# UNITED STATES PATENT AND TRADEMARK OFFICE

APPLICATION NO.	FILING DATE	FIRST NAMED INVENTOR	ATTORNEY DOCKET NO.	CONFIRMATION NO.
09/986,956	11/13/2001	Manuel Barbosa	1356-041	6385
25215 7590 02/28/2007 DOBRUSIN & THENNISCH PC 29 W LAWRENCE ST SUITE 210 PONTIAC, MI 48342			EXAMINER NGUYEN, XUAN LAN T	
			ART UNIT	PAPER NUMBER
			3683	
SHORTENED STATUTORY PERIOD OF RESPONSE		MAIL DATE	DELIVERY MODE	
3 MONTHS		02/28/2007	PAPER

## Office Action Summary

## DETAILED ACTION

FIG 1

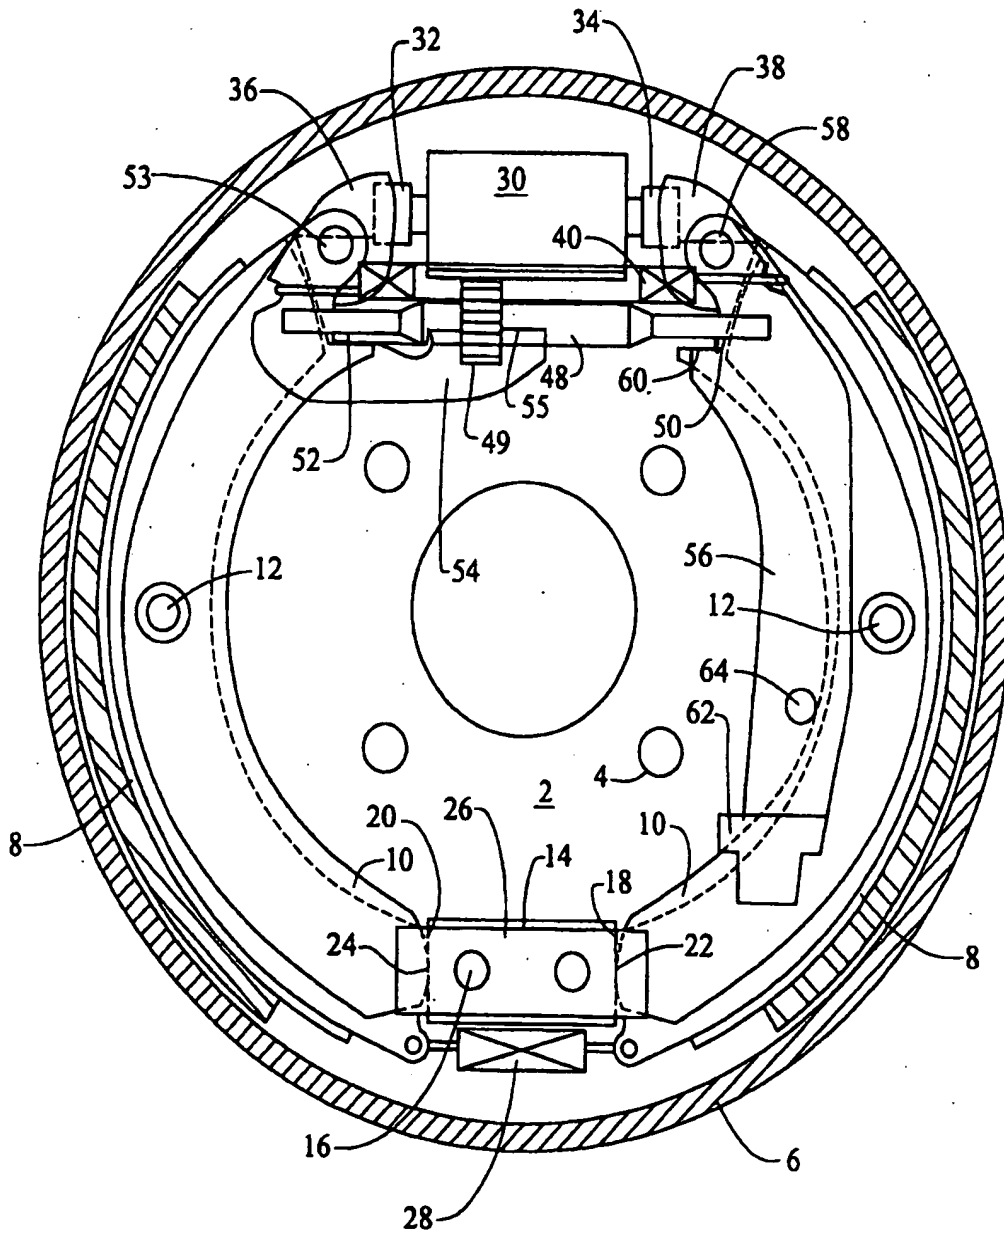
1. The drawings were received on 1/19/07. These drawings are not approved.
2. The drawings are objected to under 37 CFR 1.83(a). The drawings must show every feature of the invention specified in the claims. Therefore, the claimed feature "first and second actuating lever being configured to **selectively** engage the lower anchor block" in claims 15 and 26 must be shown or the feature(s) canceled from the claim(s). No new matter should be entered. Please note page 4 of the specification, paragraph 16 where it states "A spring 28 is connected between the ends of the levers to hold ends 22 and 24 to surfaces 18 and 20."

3. The drawings are further objected to under 37 CFR 1.83(a). The drawings must show every feature of the invention specified in the claims. Therefore, the claimed feature "a first spring for connecting the lower portion of the first and second brake shoes for maintaining contact of the first and second brake shoes against the surface of the lower actuating block" in claims 24 and 26 must be shown or the feature(s) canceled from the claim(s). No new matter should be entered. Please note page 4 of the specification, paragraph 16 where it states "A spring 28 is connected between the ends of the levers to hold ends 22 and 24 to surfaces 18 and 20."

NOT  
approved  
2/22/07  
XLW

Corrected drawing sheets in compliance with 37 CFR 1.121(d) are required in reply to the Office action to avoid abandonment of the application. Any amended replacement drawing sheet should include all of the figures appearing on the immediate

FIG

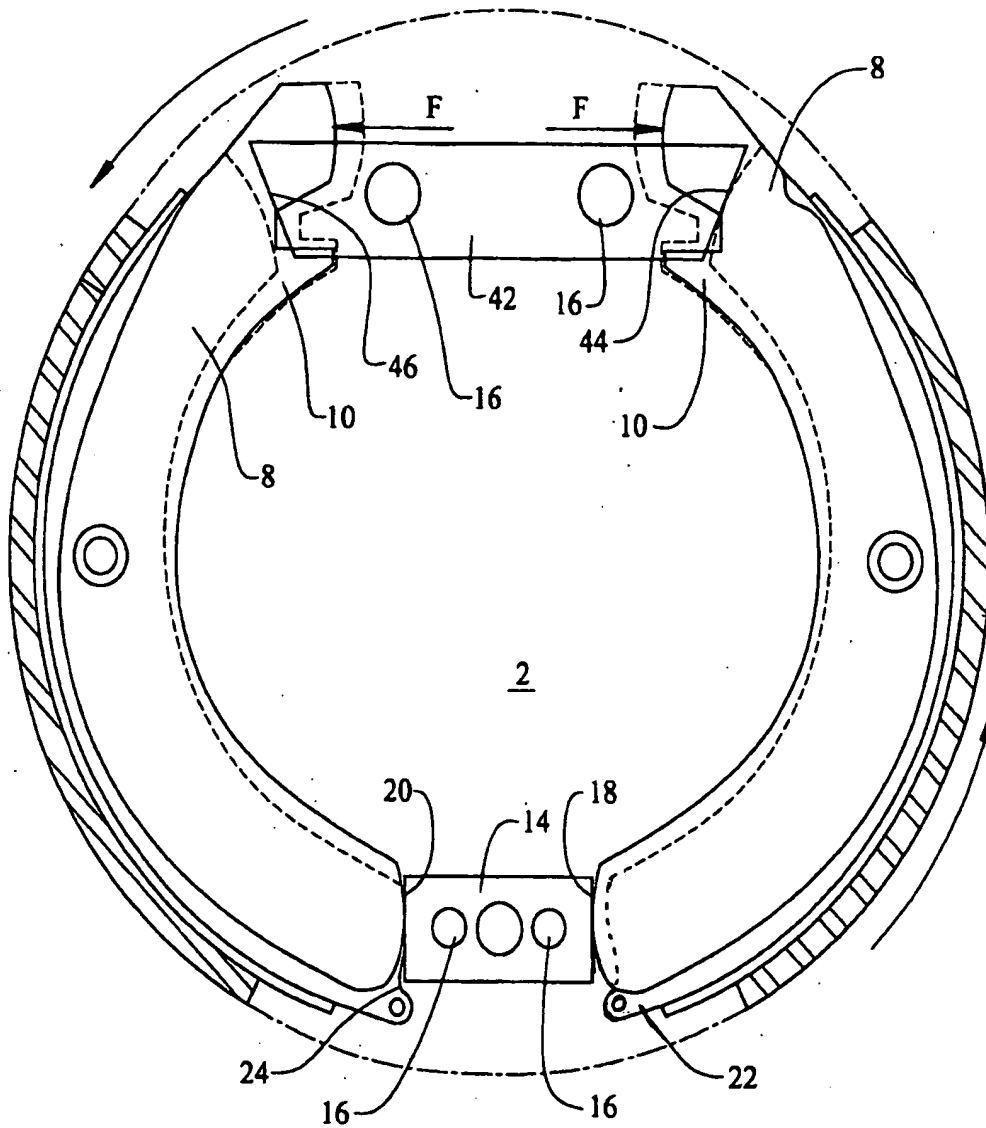
Not  
approved  
2/22/07  
XLN
